Grand Teton National Park
Moose-Wilson Corridor Road Safety Audit

Conducted September 9-11, 2013

Figure 10 - Turning Movements at LSR

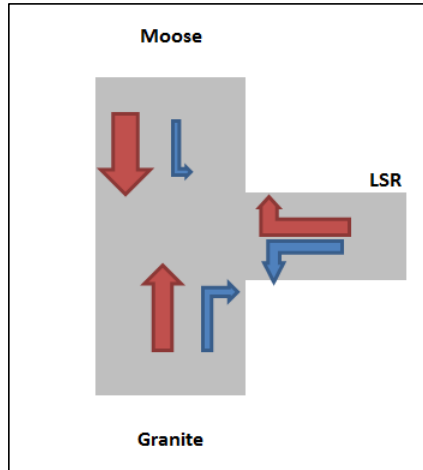
Comment [SO2]: A little confusing since MWR is running east-west in this location ... perhaps you could say "northbound, right-turning"

Figure 12 - Crashes by Month, 2002-2012

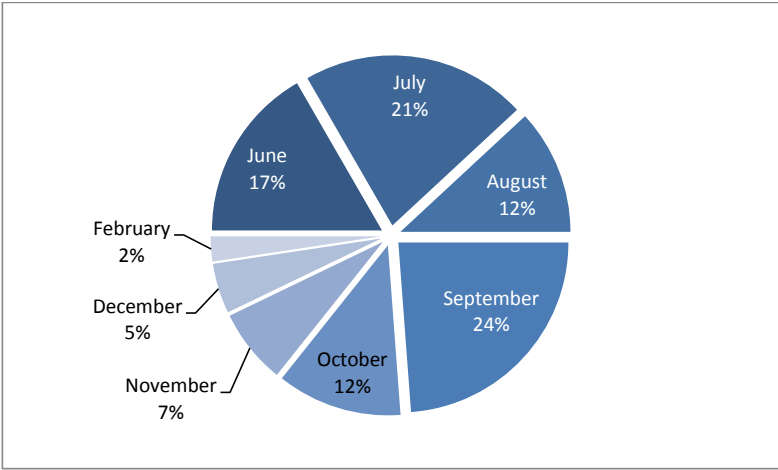
Comment [S04]: Of course, MWR is closed between Granite and Death Canyon for six months of the year – approx. Nov1 – May 1.
